SUNSET VILLAGE FILING NO. 4

CONSTRUCTION PLANS

EPC STORMWATER REVIEW COMMENTS
IN ORANGE BOXES WITH BLACK TEXT

MODIFIED FOR S.I.A. CD SET
RICHARD D. LYON, PE
ATWELL, LLC
DECEMBER, 2021
EPC PROJ.: CDR-21-008

SHEET 1 OF 22

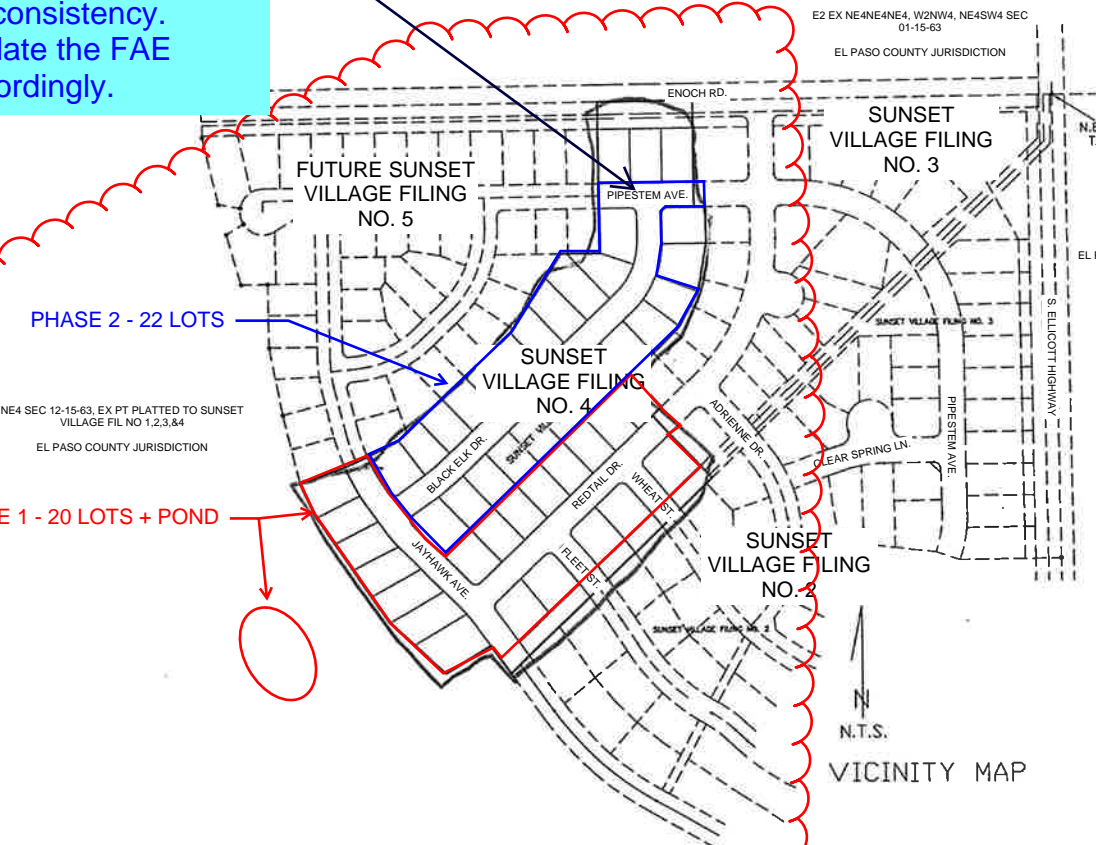
Sheet 3 notes
Pipestem as part of
Phase I. Update
either the phase
boundary or sheet 3
for consistency.
Update the FAE
accordingly.

revise to match GEC Checklist Item "ii"

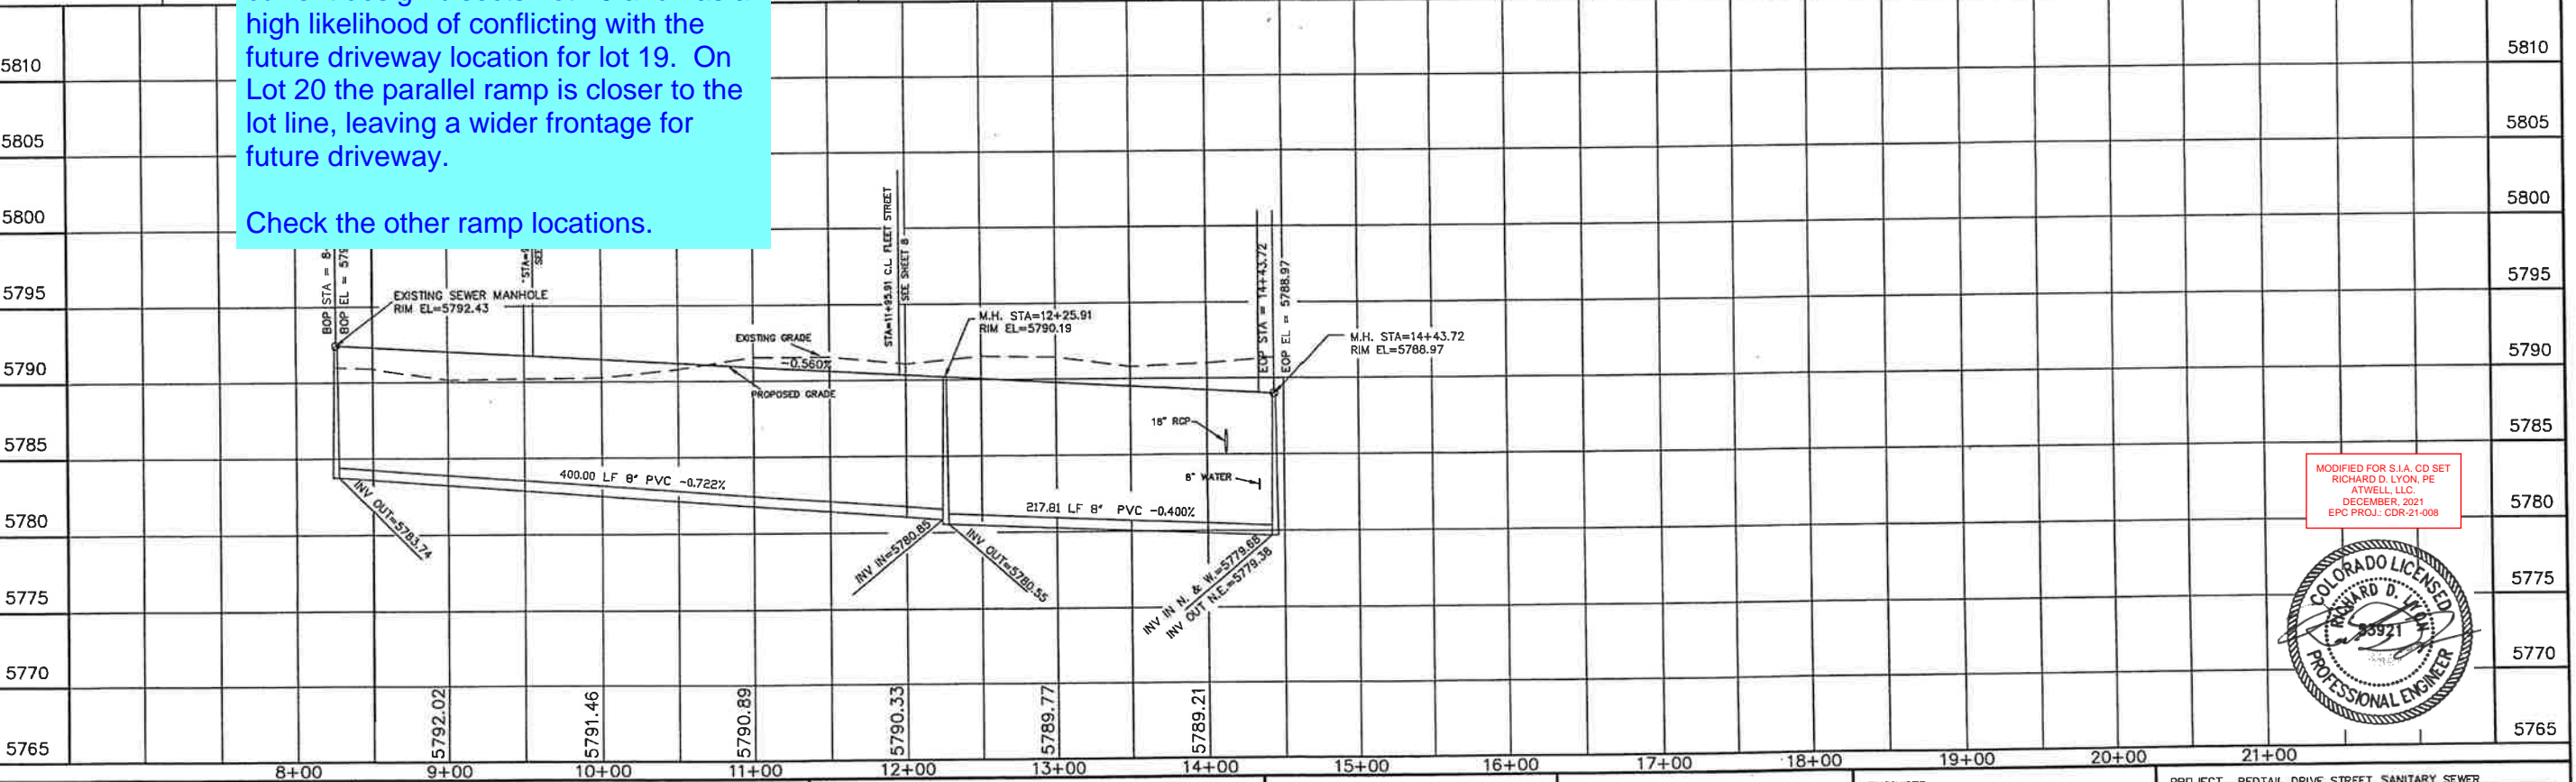
Relocate ramp to the other side. The current design bisects Lot 19 and has a high likelihood of conflicting with the future driveway location for lot 19. On Lot 20 the parallel ramp is closer to the lot line, leaving a wider frontage for future driveway.
Check the other ramp locations.

PROJECT: JAYHAWK AVE - STREET, SANITARY SEWER
 FROM: 0+00 TO: 6+22.76
 SUBDIVISION: SUNSET VILLAGE FILING NO. 4
 DRAINAGE BASIN: TELEPHONE EXCHANGE
 JOB NO. D:\PROJ\00-0908\RCP01004.DWG SHEET 6 OF 22

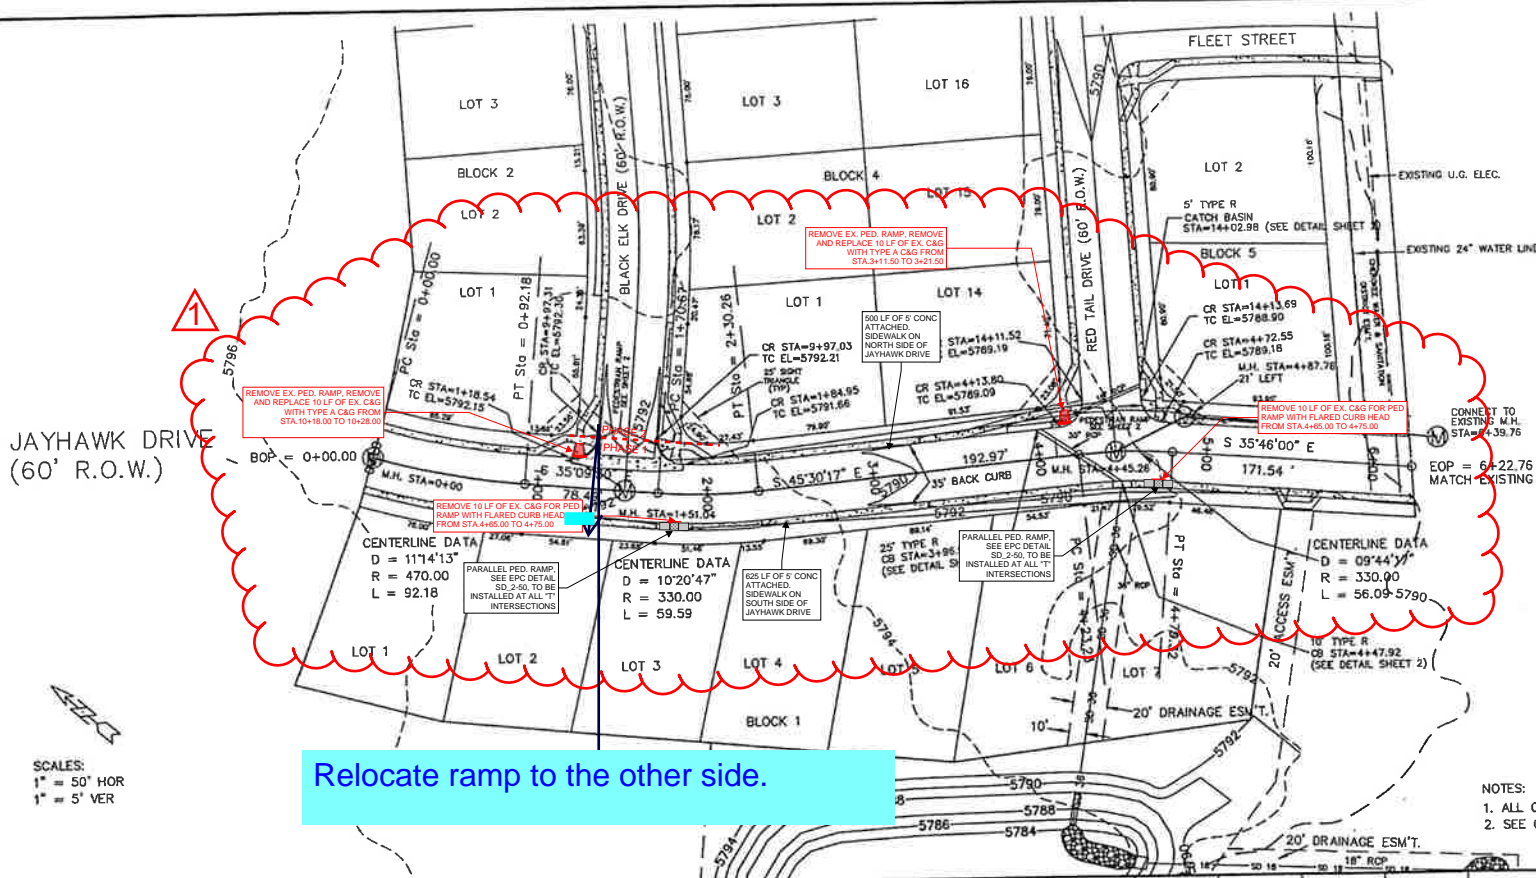
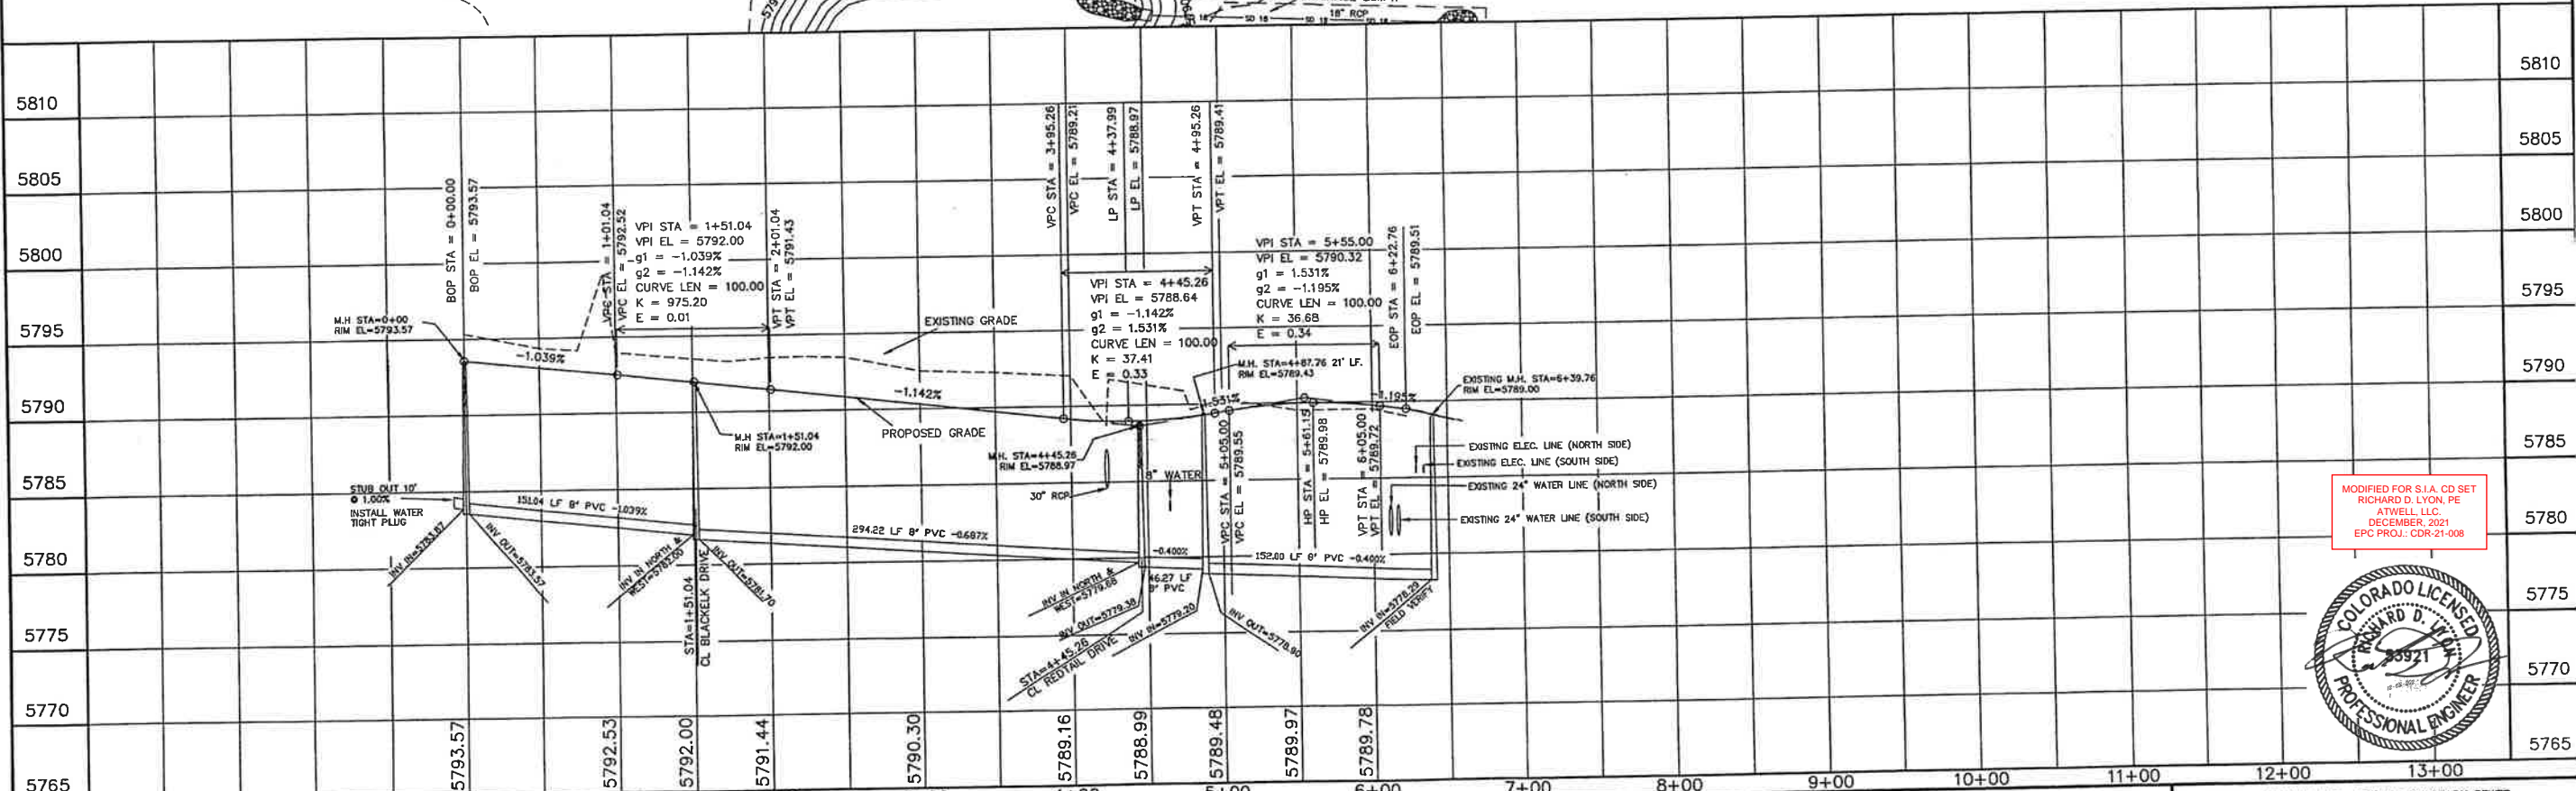
Relocate ramp to the other side.

SUNSET VILLAGE FILING 4 GRADING AND EROSION CONTROL PLAN

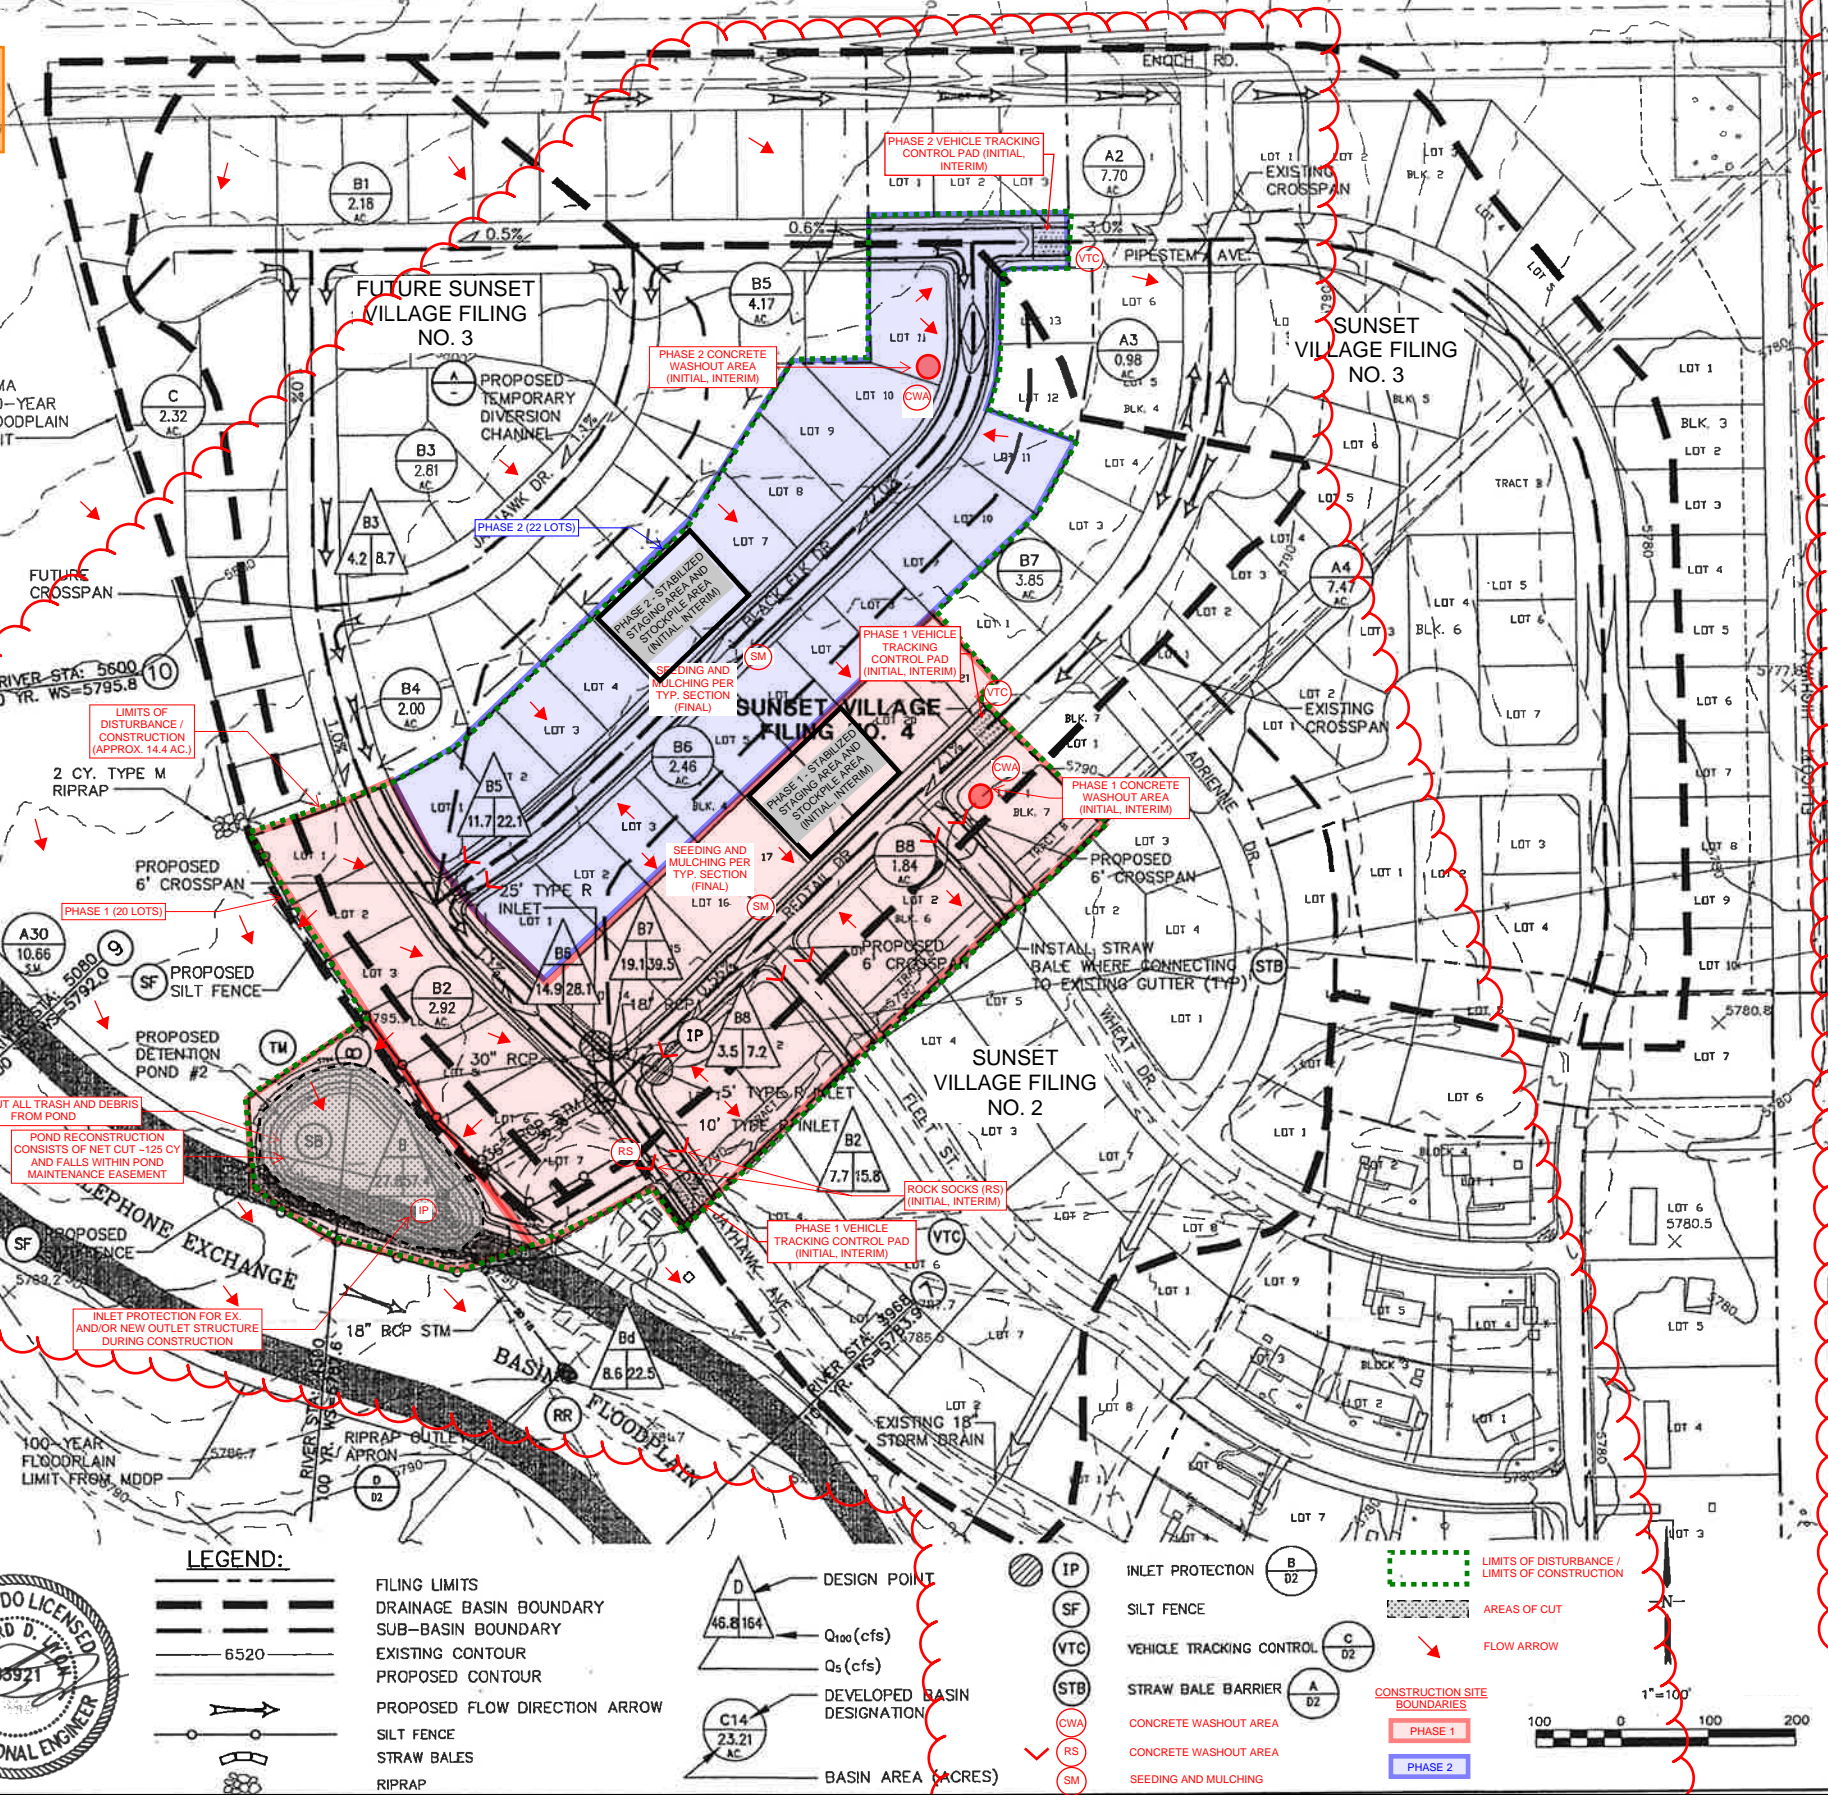
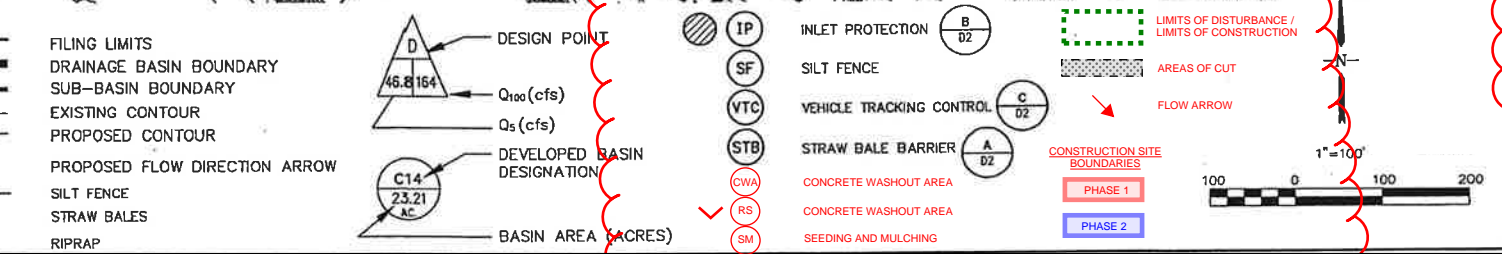
It makes sense to just remove all of these signature blocks from this sht since there are already some on Sht 1. This is redundant.

Missing final sentence of statement per GEC Checklist Item "ff".

Does not match Item "hh".

This should say:
Jennifer Irvine, P.E.
County Engineer / ECM Administrator
